Access Compliance Report

Public Rights-of-Way

(Curb Ramps)

Intersection ID: 28903	Main Street: CAMPUS_WALK_LN	Cross Street: JOHN_KIRK_DR	Location: NW
ADA ID: 9EF69809AAE7	Ramp Type: PerpDiag	Initial Pass/Fail: Fail	Overall Compliance: No
Codes/Mitigation Info/Possible Solution		Field Measurements/Component Compliance	
Severity Score: 33.75

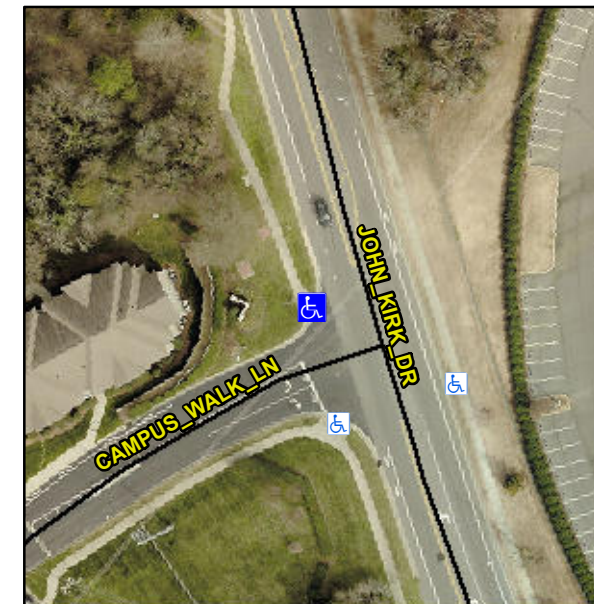
R304.5.1, R304.2.2

Compliance	Description	Data	Compliance	Description	Data
N/A	Ramp Length (in)	65.0	No	Ramp Slope (%)	19.0
No	Ramp Width (in)	44.0	Yes	Ramp XSlope (%)	2.0
N/A	Flare Type LT	N/A	N/A	Flare Type RT	N/A
N/A	Flare Slope LT (%)	N/A	N/A	Flare Slope RT (%)	N/A
N/A	Flare Traversable LT?	N/A	N/A	Flare Traversable RT?	N/A
N/A	Landing Length (in)	N/A	N/A	DWS Provided?	N/A
N/A	Landing Width (in)	N/A	N/A	DWS Contrast?	N/A
N/A	Landing Slope (%)	N/A	N/A	DWS Length (in)	N/A
N/A	Landing X Slope (%)	N/A	N/A	DWS Full Width?	N/A
N/A	Landing Curb? (Y/N)	N/A	N/A	DWS Offset (in)	N/A
N/A	Shared Landing?	N/A			
N/A	Gutter Ponding?	N/A	N/A	Gutter Slope (%)	N/A
N/A	Gutter Lip Ht (in)	N/A	N/A	Gutter X Slope (%)	N/A
N/A	Painted X Walk1?	No	N/A	Painted X Walk2?	No
	X Walk 1 Direction	To S		X Walk 2 Direction	To E
N/A	X Walk 1 Width (in)	N/A	N/A	X Walk 2 Width (in)	N/A
	X Walk 1 Slope (%)	4.1		X Walk 2 Slope (%)	7.1
	X Walk 1 X Slope (%)	5.7		X Walk 2 X Slope (%)	1.1

Remove & Replace Curb Ramp With Two New Directional Ramps or Equivalent.
